Well Name: GISSLER B	Well Location: T17S / R30E / SEC 14 / SWNW / 32.8396783 / -103.9437056	County or Parish/State: EDDY / NM
Well Number: 38	Type of Well: OIL WELL	Allottee or Tribe Name:
Lease Number: NMNM2748	Unit or CA Name:	Unit or CA Number:
US Well Number: 300153435900S1	Operator: BURNETT OIL COMPANY INCORPORATED

Sundry ID: 2870237

Type of Submission: Notice of Intent	Type of Action: Plug Back
Date Sundry Submitted: 08/27/2025	Time Sundry Submitted: 09:42
Date proposed operation will begin: 09/18/2025

Conditions of Approval for Permanent Abandonment of a Production Zone

PROPOSED WBD

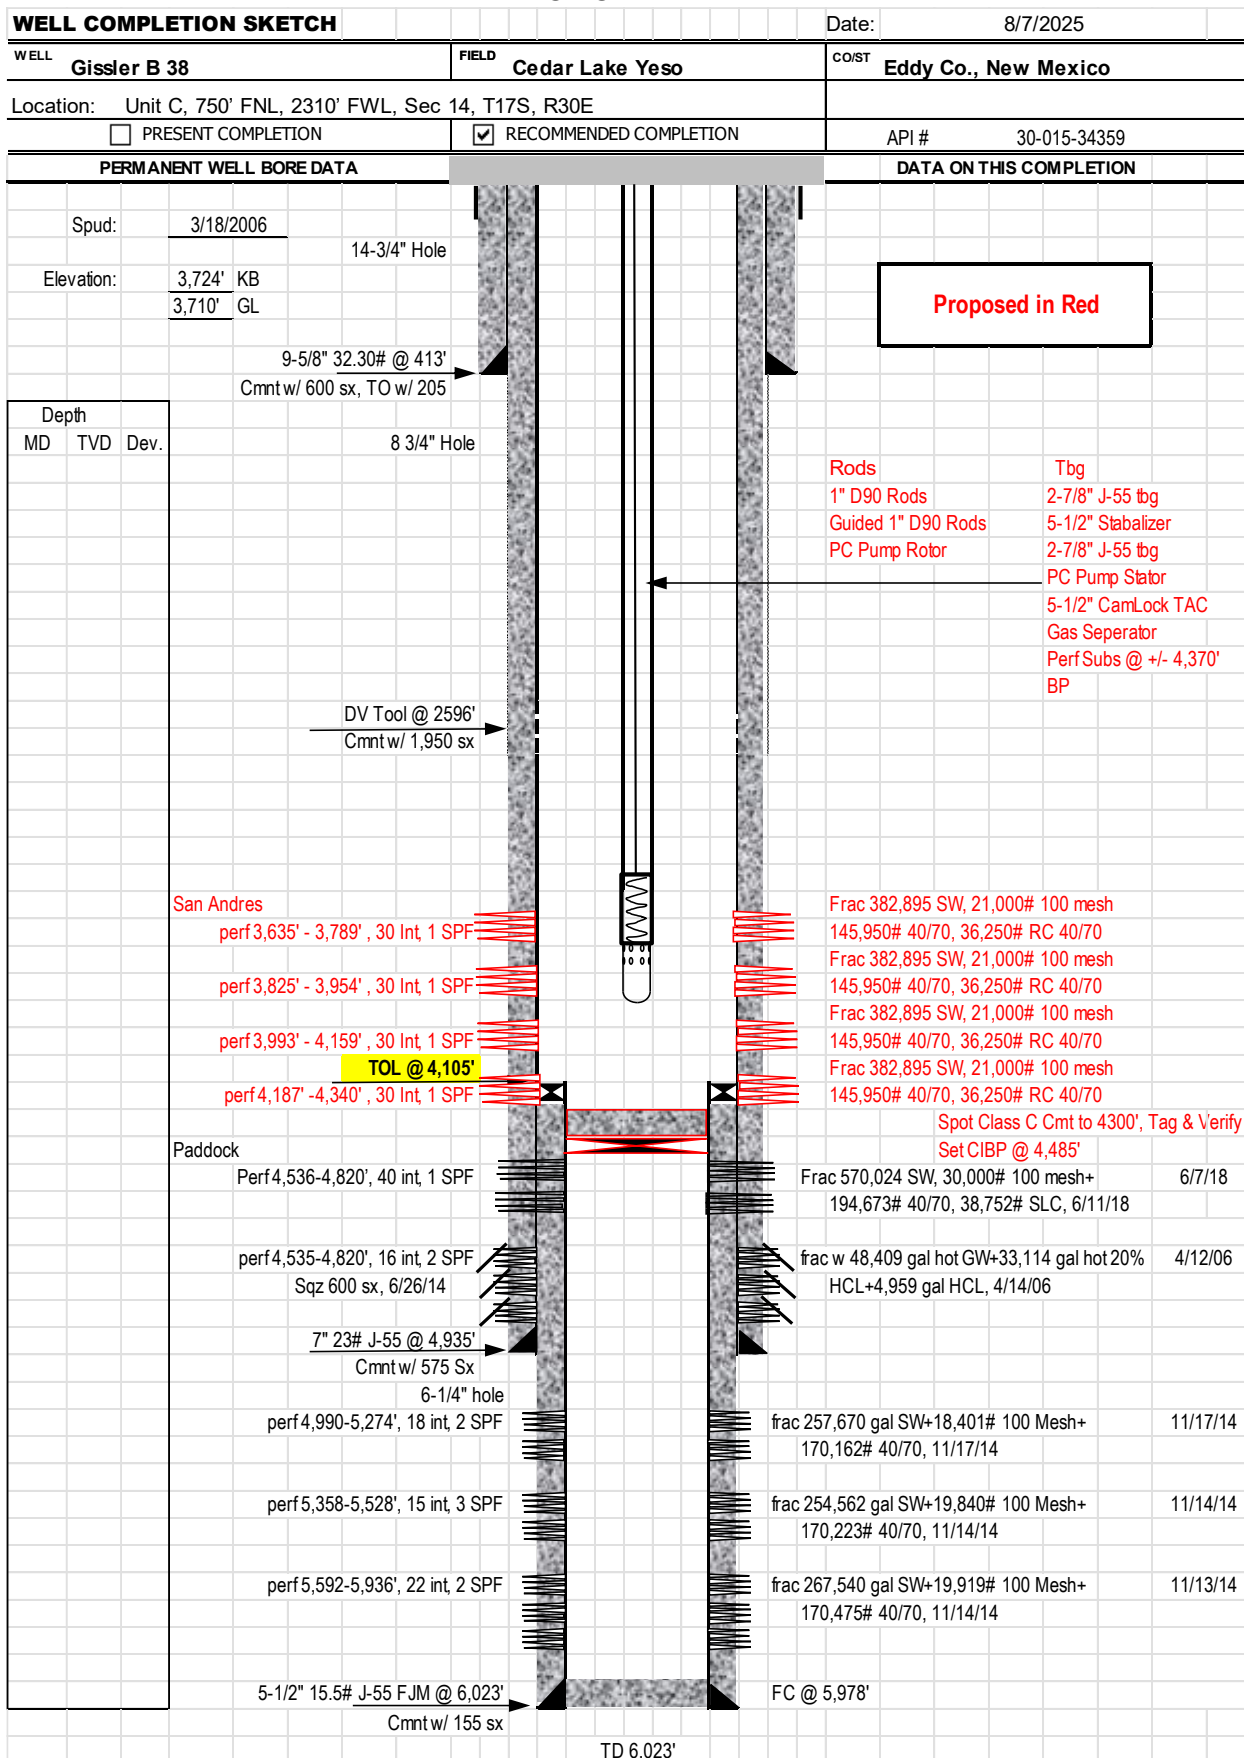
Well in Lesser Prairie Chicken Area. Please review additional requirements in COA below

- 4) MIRU WL. RIH & set 5-1/2" CIBP @ +/- 4,485'. **Spot Class C cmt on top of CIBP to 4300'. 25sks minimum, verify Top of cmt. Covering Glorieta top.**

Please review BLM conditions of approval following this procedure below.
